GNRO-2013/00050

SUBJECT: Criticality Safety Analysis License Amendment Request -
Responses to NRC Requests for Additional Information

Grand Gulf Nuclear Station, Unit 1
Docket No. 50-416
License No. NPF-29

**RESPONSES TO NRC REQUESTS FOR ADDITIONAL INFORMATION -
GGNS CRITICALITY SAFETY ANALYSIS LICENSE AMENDMENT REQUEST**

Figure 3-1: Subsets of Database with 95/95 Fit

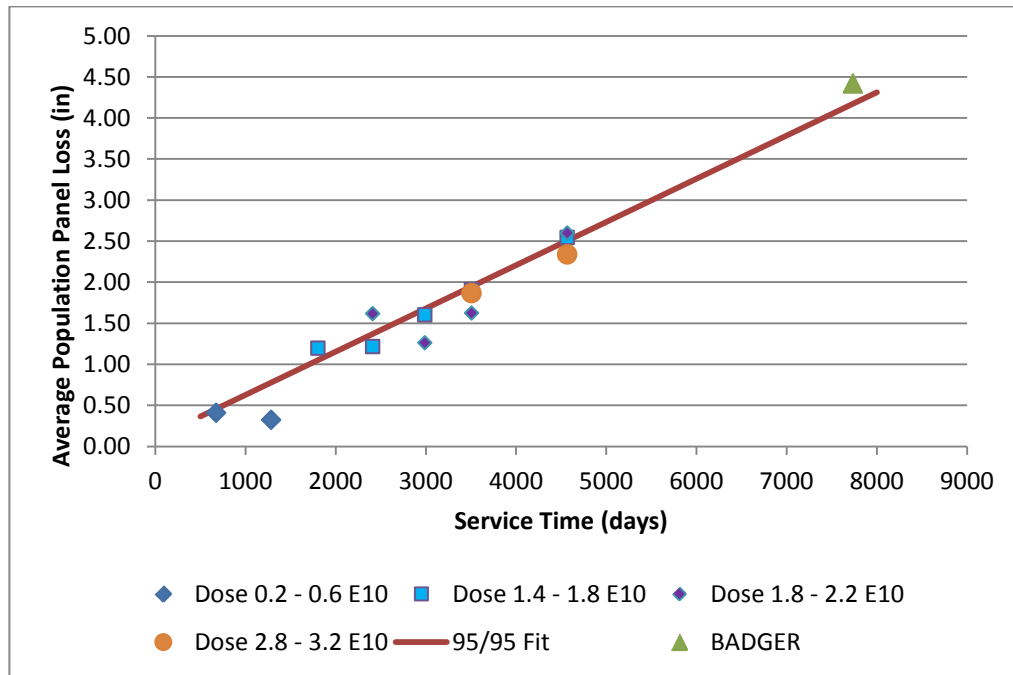
- 1) Please clarify if the issue of on-going Boraflex dissolution has been adequately incorporated. From the available literature, dissolution appears to have a significant effect on the edges of the panels, effectively reducing their width and length beyond the radiation damage-induced shrinkage. Boraflex dissolution does not appear to be limited to very high dose panels. The distributions used to describe the degraded Boraflex need to include consideration of the following:

Describe how these considerations are included in the development of the distributions used to simulate the degraded Boraflex. Where the issues have not or cannot be covered, please provide a quantified justification to support the acceptability not considering these issues.

The GGNS Boraflex gap measurements are summarized in Figure 1 provided in GNRO-2010/00073. That figure shows the evolution of Boraflex panel losses based on Blackness test measurements over the first 13 years of rack in-service life and the BADGER measurement that occurred after 21 years of in-service life. Figure 1 presents the measurement database as a function of panel dose that has been shown to be related to panel shrinkage. For racks with an in-service life like GGNS, dissolution effects are dominantly impacted by the time a given panel has exceeded a relatively small dose. The GGNS measurement database reflects both shrinkage and dissolution effects. In order to separate the effects, sub-sets of the database were selected with a similar dose (i.e., narrow range of dose values). Since these panels achieved the target dose over different time periods, the panel loss attributable to dissolution effects over time can be evaluated. For this evaluation, the time since the initial irradiation is used (i.e., the end of Cycle 1 in 1986). Four separate sub-sets of the database were compiled, with different target dose values. The dose targets cover a wide range of dose values, with some extending above the Region I dose limit. The evaluation of this data is illustrated in Figure 3-1, below, which shows a strong relationship of panel loss with time that is not dependent on dose.

A regression fit of the data resulted in an R-squared value of 0.906. The BADGER test data was not included in the development of the correlation since there are too few measurements with a common dose or irradiation history. However, subsets of low dose, long in-service life panels from the BADGER measurements demonstrate the correlation's applicability. The 95/95 upper limit of the fit is used to evaluate the dissolution effects on gap growth for the GGNS racks.

Figure 3-5: Axial Probability Distribution of Dissolution Features

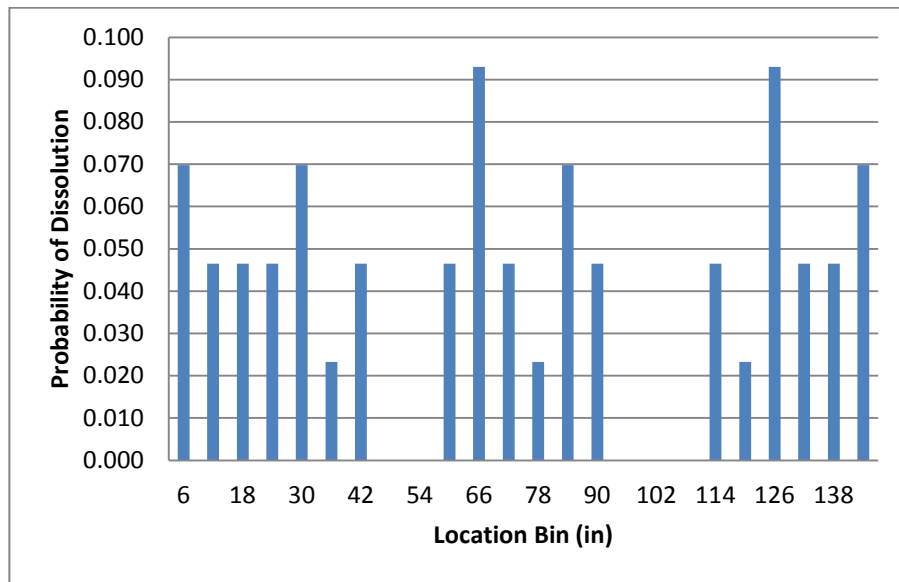
- *Effects of scallop formation and any other forms of localized thinning*
- *Future panel dissolution*
- *Local (i.e., from panel to panel) dissolution rate variation that would occur due to manufacturing and environmental variations*
- *Local dissolution rate variation due to manufacturing defects and fuel storage rack damage*

In addition to the gap growth due to dissolution discussed above, the reactivity effects of areas of local dissolution have been evaluated based on analysis of the BADGER test data. Detailed maps of the BADGER measurements for the Region I and Region II panels were analyzed to determine the location and geometry of areas where local dissolution is present. The evaluation considered dissolution features (e.g., scallops) associated with Boraflex gaps separately from dissolution features that are not associated with gaps. Features associated with gaps have the same location distribution as gaps. Features not associated with gaps are observed to be uniformly distributed axially, as shown in Figure 3-5, below.

For both sets of dissolution features, the dimensions of each feature were determined and a 95/95 upper limit was calculated, as summarized in Table 3-1, below.
